Appl. No. 10/766;611
Amdt. dated 7 May 2008
Reply to Office action of 7 February 2008

Amendments to the Drawings:

REMARKS

FIG. 1

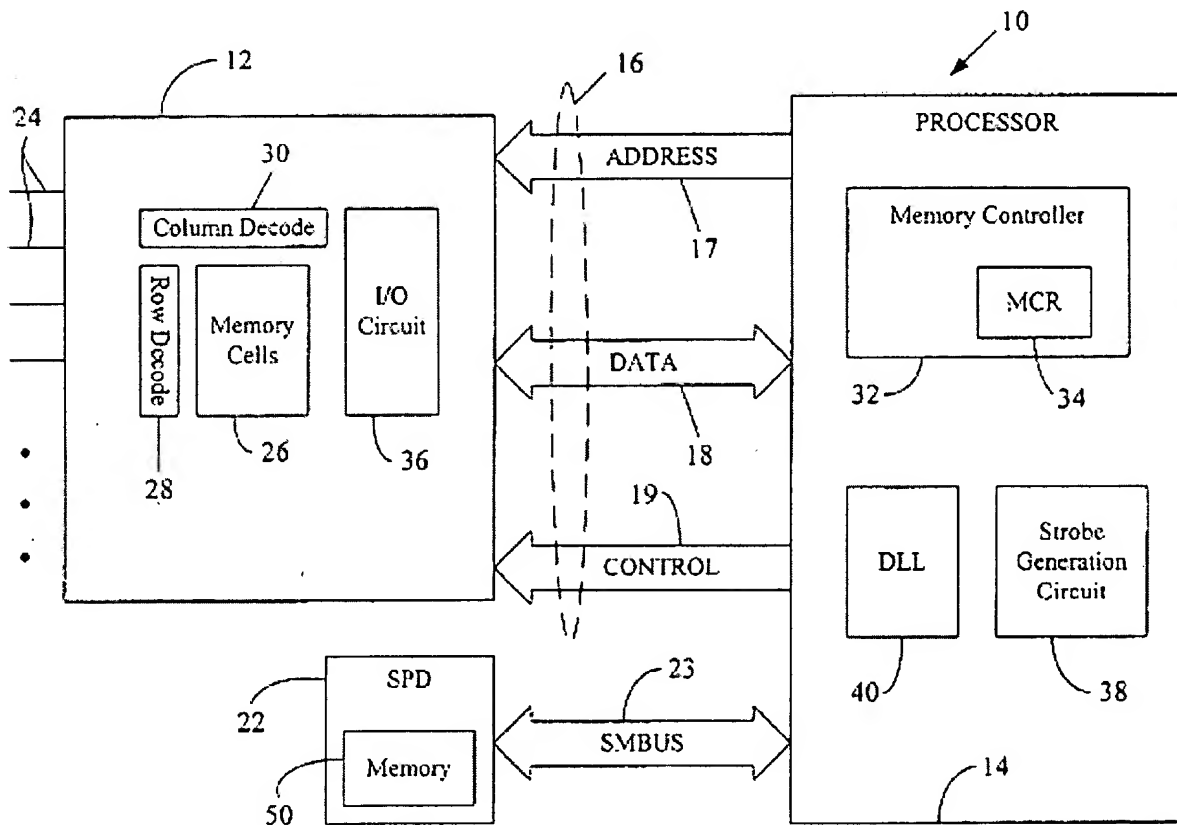
With further reference to claim 20, claim 20 recites a memory chip having a serial presence detect circuit containing a plurality of test bits and a plurality of memory cells to store data. Claim 16 recites a similar feature. In the rejection of claim 20 in paragraph 7, the Office action cites only to memory chip 505 in Silvestri. It is respectfully submitted that this citation is insufficient. For anticipation under 35 U.S.C. § 102, the reference must teach every aspect of the claimed invention either explicitly or impliedly. See MPEP § 706.02(a)(IV). An example of a memory chip having a serial presence detect circuit is shown in Figure 1 of the instant application at 22, which is reproduced here for convenience:

Because the cited memory chip 505 in Silvestri does not teach a serial presence detect circuit containing a plurality of test bits, it is respectfully requested that the rejection of claim 20 be withdrawn.

FIG. 2

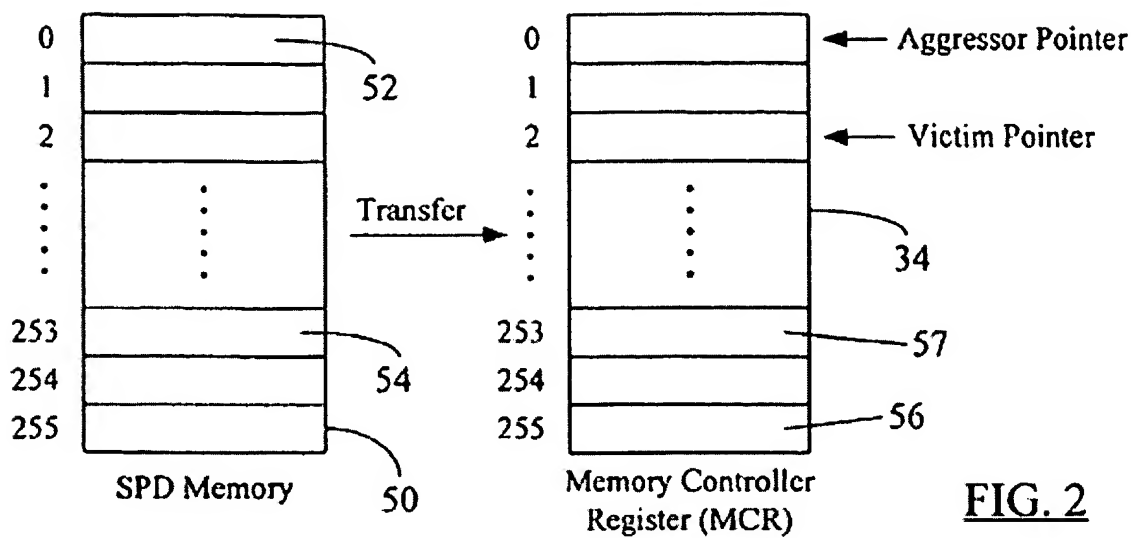
Storing said plurality of signals in a serial presence detect circuit (Claim 6)

Transferring said plurality of signals stored in said serial presence detect circuit into a memory controller (Claim 6)

This step is shown in Figure 2, showing a memory test pattern stored in an SPD memory being transferred from the SPD circuit memory 50 to a memory controller 34 as described in paragraphs [0029]-[0030].

This step is also shown in Figure 2, showing a memory test pattern being transferred from an SPD circuit memory 50 to a memory controller 34 as described in paragraphs [0029]-[0030].
